State of Connecticut
Department of Transportation

SUPPLEMENTAL SPECIFICATIONS
TO
STANDARD SPECIFICATIONS
FOR ROADS, BRIDGES, FACILITIES
AND INCIDENTAL CONSTRUCTION

JULY 2021

Figure 4.07-1: DETAILS AND SECTIONS OF RUMBLE STRIPS

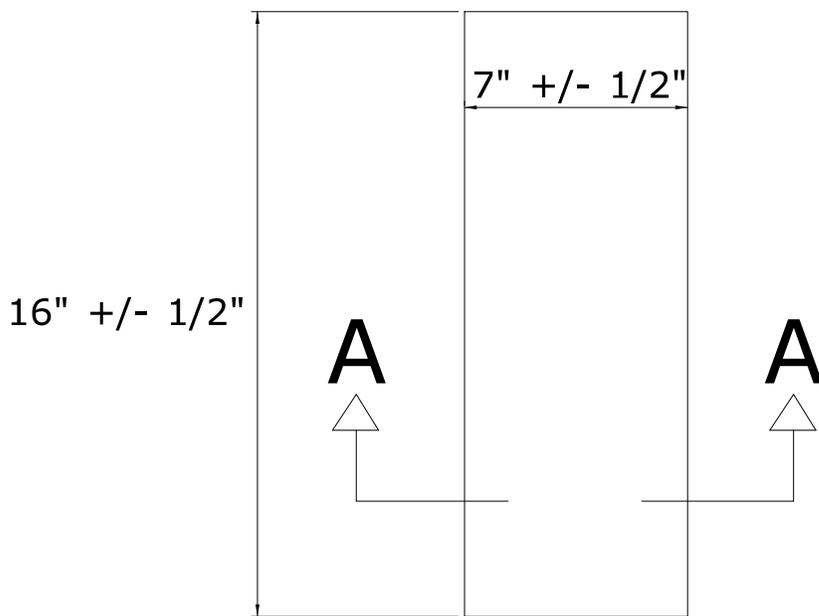
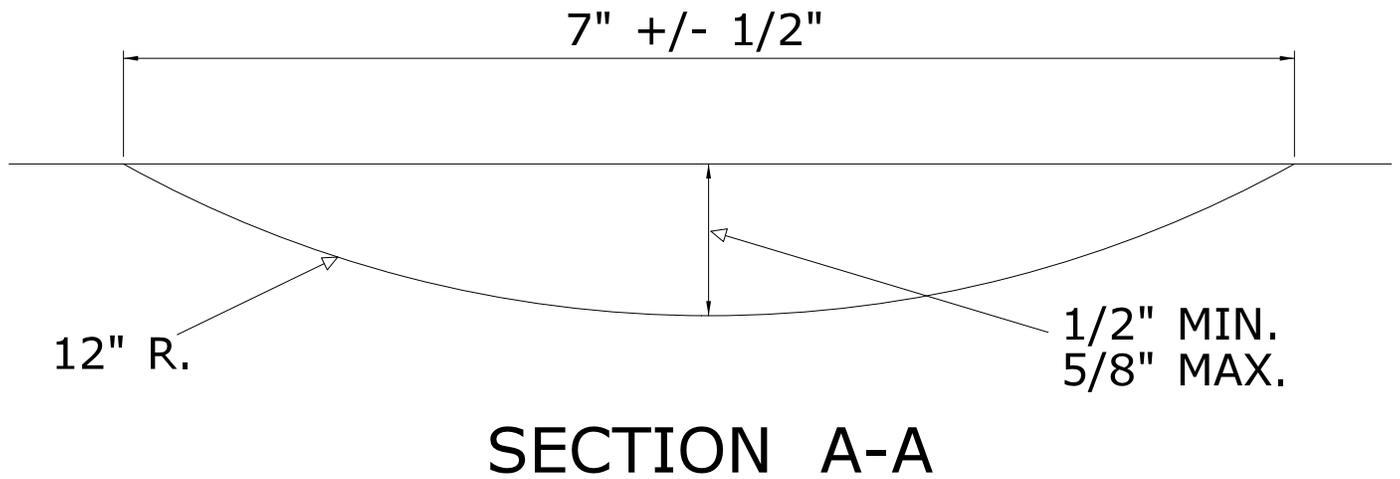
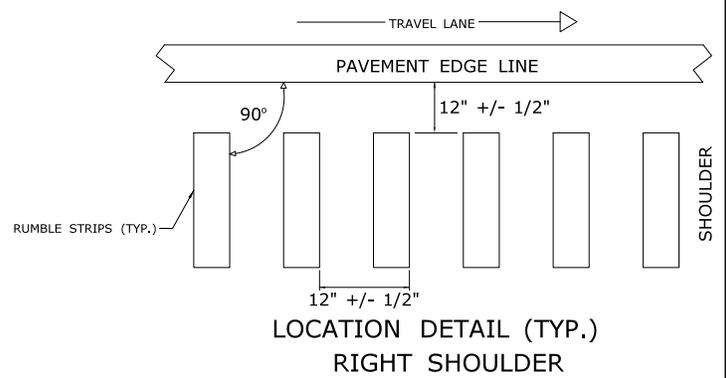
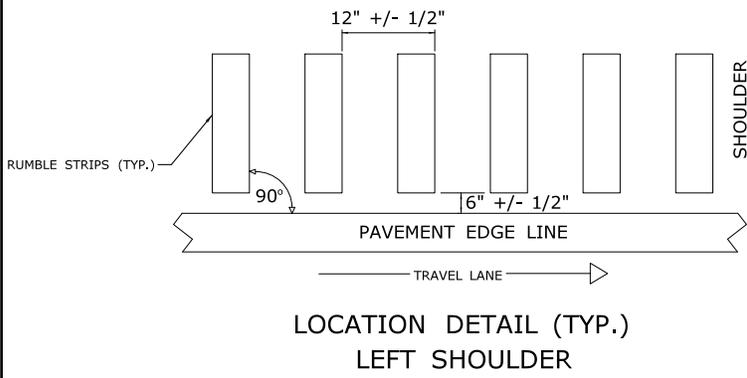
to the patterns shown in the plans or in Figure 4.07-1. Alignment of the edge of the cut shall be checked and verified by the Engineer.

The width of milling shall be as specified on the Plans or other specifications. If no other width specification exists, the minimum width of milling for freeway shoulders shall be 20 inches, and for all other rumble strips the minimum width of milling shall be 14 inches in order to completely remove

Figure 4.07-2: TYPICAL TREATMENTS FOR INSTALLING RUMBLE STRIPS

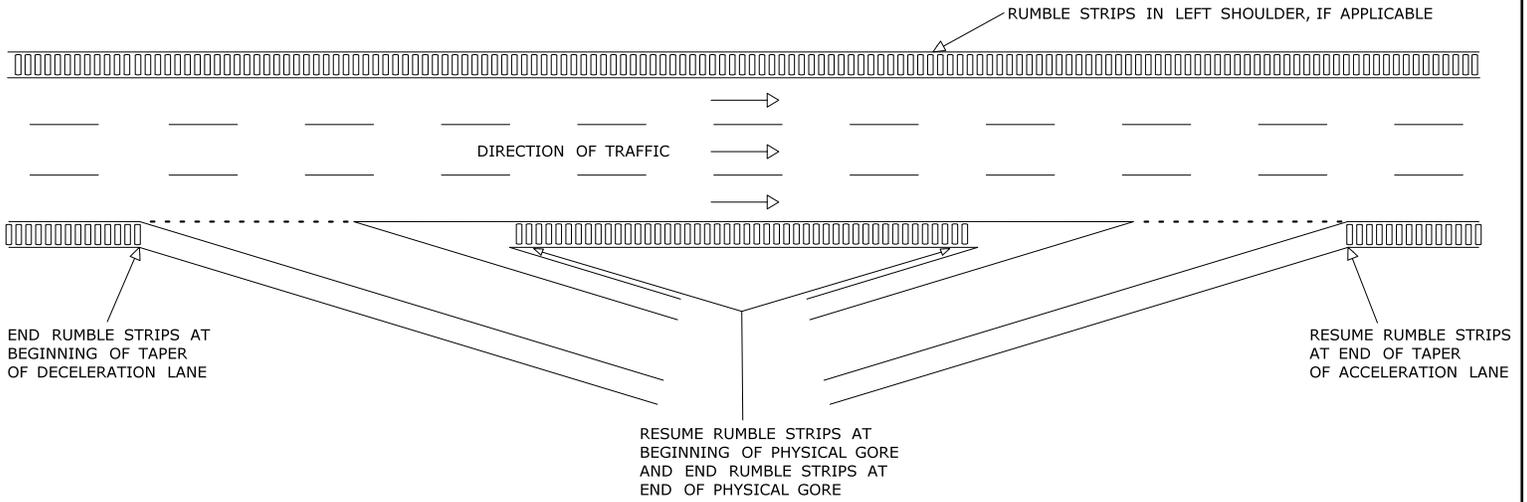
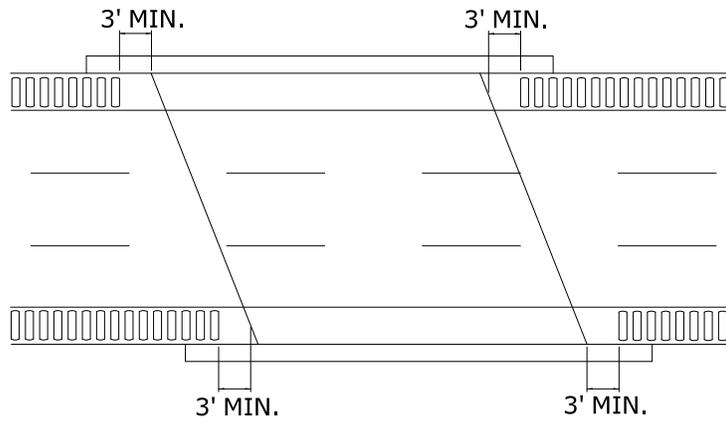
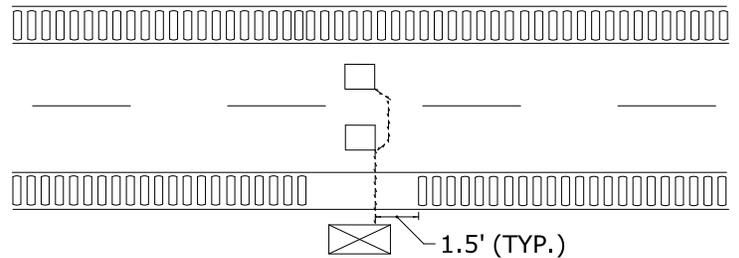
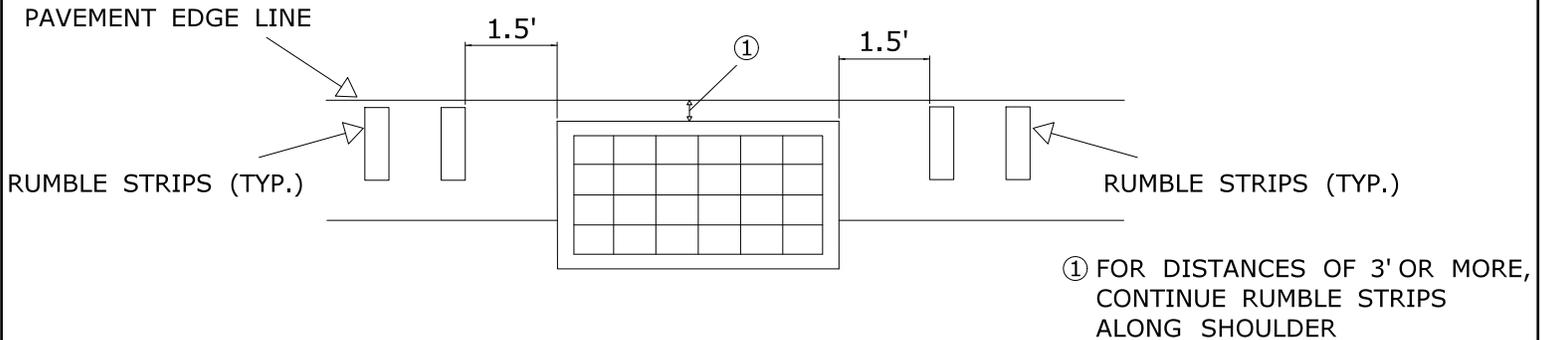
NOTE: REVISE DISTANCE FROM EXPANSION JOINT AS NEEDED FOR NARROW SHOULDERS APPROACHING BRIDGES
